Appeal Ref: APP/A3655/W/20/3265969
Appeal Ref: APP/A3655/W/20/3265974
Site Addresses: Land South of Kingfield Road
and East of Westfield Avenue, Westfield Avenue,
Westfield, Woking and Land South of Hoe Valley
School, Woking

WOKING FOOTBALL CLUB WOKING

Clarification of Architectural and Landscape
Information in response to DSE Comments 2.4 and
2.5 of the Design Review Panel

MAY 2021 | 7884-L(00)745

PUBLICLY ACCESSIBLE AREA BEFORE

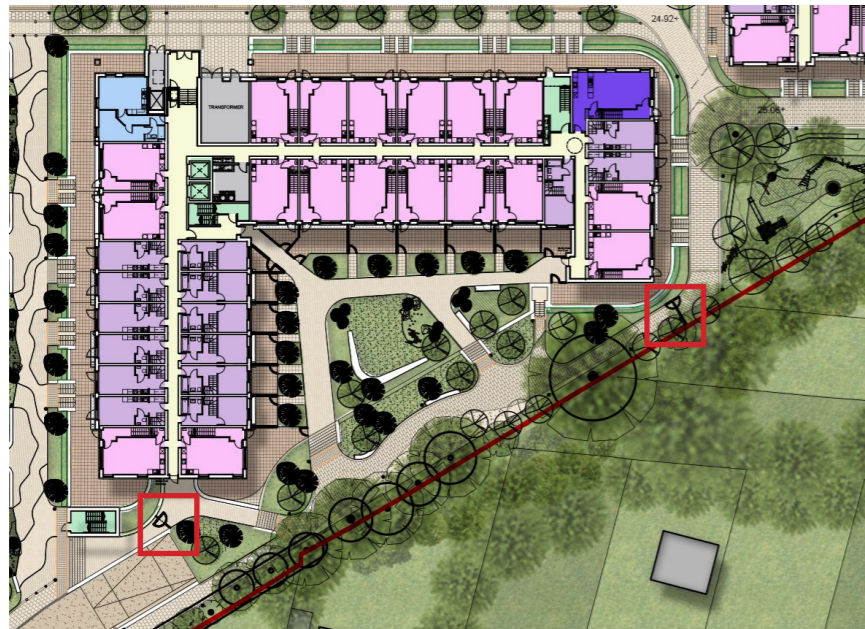
- 2.4 The tight proximity of Blocks 4 and 5 to the site boundary has resulted in narrow and dark alleyways to the rear of the residential blocks. We urge the design team to provide detailed boundary treatment sections to show the relationship between the buildings and the site boundary to demonstrate how more space will be provided at the edge of the development for the provision of safe and well-lit pedestrian routes.
- 2.5 While the orientation and location of Blocks 1 - 3 successfully respond to both the stadium and surrounding streets, this approach has not been extended to Blocks 4 - 5, which makes the design strategy appear unfinished. We recommend further consideration of the orientation of Blocks 4 - 5, to better engage with the different context and edge conditions addressed by each block.

The issue raised here was principally regarding a concern about the routes being ‘safe and well lit’ – with ‘safety’ being the main issue. The main issue **was not** the width of the space from a design perspective but about ‘**safety**’ and ‘**lighting**’.

The key change on the plans was to make these spaces ‘**non public**’ and gate these with access control to allow residents access only. This means the potential ‘safety’ risk identified by the DSE was **resolved**.

The following plans illustrates the significant change in the nature and thus improved safety of the spaces, comparing the before and after scenarios, and then identifies the revised plan with the amendments highlighted following the review. The conclusion of that review did not necessitate a change to the block positions.
